#### LARAMIE COUNTY PLANNING & DEVELOPMENT DEPARTMENT

#### MEMORANDUM

TITLE: Review and action of a Subdivision Permit and Plat for Saddleback Acres,

## FINAL PLAT

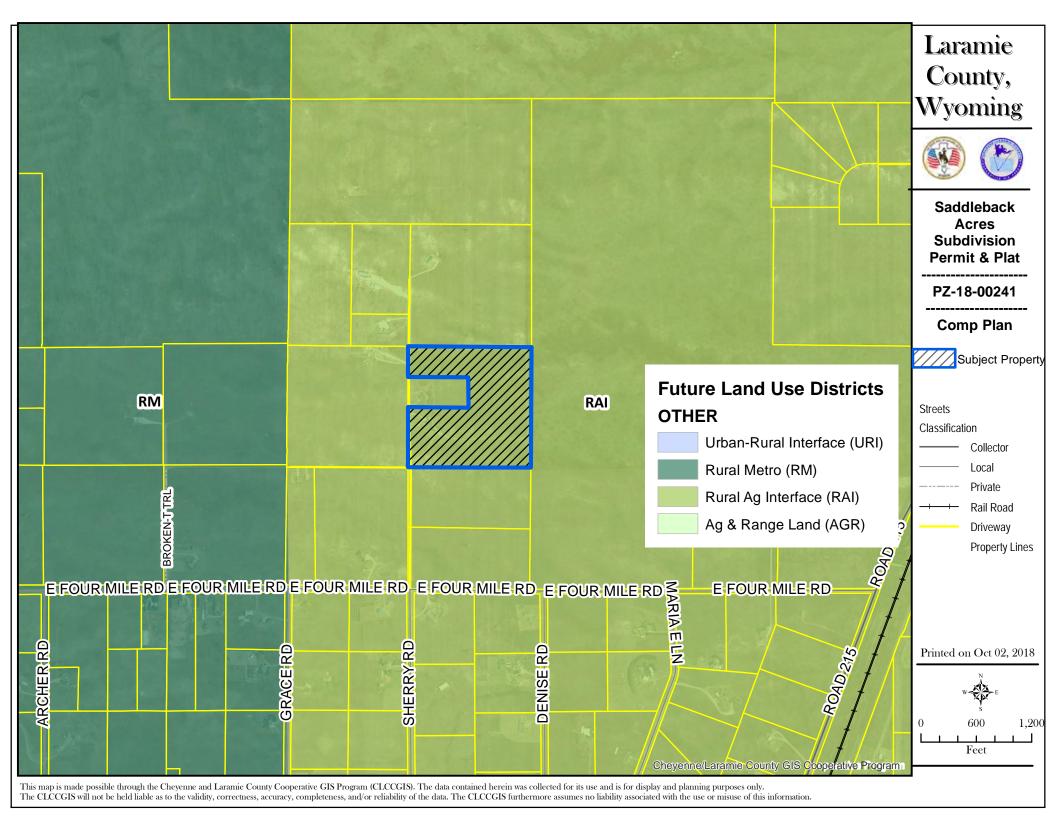
Upon further review of the plat, staff finds that clarification is needed regarding the 40-foot easement (labelled right-of-way) located along the west boundary of the subdivision. Is the ingress/egress easement to continue as privately maintained with access available for public utility use, or be dedicated as public right-of-way?

- 1. The plat is required to have a statement describing the type of sewage disposal, the type of water supply and the type of fire protection proposed to serve the subdivision/development. There is no statement regarding fire protection. Also, Note 6 says that the water souce is a 200 foot deep well on the property. Is this one well to serve all lots or will there be individual wells for each lot. This needs to be clarified on the plat. Similarly, Note 7 indicates that the sewer is a 1,000 gallon septic system. Is this for all lots or just one and if just one which one? Clarification on the sewage disposal type for each lot is needed on the plat.

- 1. There are 2 "LEGAL DESCRIPTION" labels on the plat and that makes it appear as though there are 2 individual descriptions, when in fact, there is only one description. It might be less confusing to others utilizing or referencing the plat if there were only one label. The bearing of West boundary of Lot 1 is defined as N00°24'13"W on the plat, but in the LEGAL DESCRIPTION the bearing is defined as N00°24'31"W. The NOTARIAL ACKNOWLEDGEMENT for the McGlothlins' should be placed next to their signatures just below the DEDICATION. In the first 2 lines of the DEDICATION "owner" should be "owners" and "does" should be "do".

- 3. There are no Wyoming State Plane Coordinate System coordinates shown on the plat.
- 4. It might make the plat easier to follow if "SHERRY ROAD (80.0 R.O.W.)" had an

arrow/leader connecting the road label to the actual road R.O.W. It appears that the only ACCESS AND UTILITY EASEMENT serving Lot 2 is 20.00 feet wide. Is that wide enough to serve the purposes indicated. Other Access and Utility easements shown on the plat are 40.00 feet wide.

1. The plat shall be amended to reflect the correct designation of the west 40-foot easement/right-of-way and a note added to clarify the intended use and maintenance, prior to plat recordation.
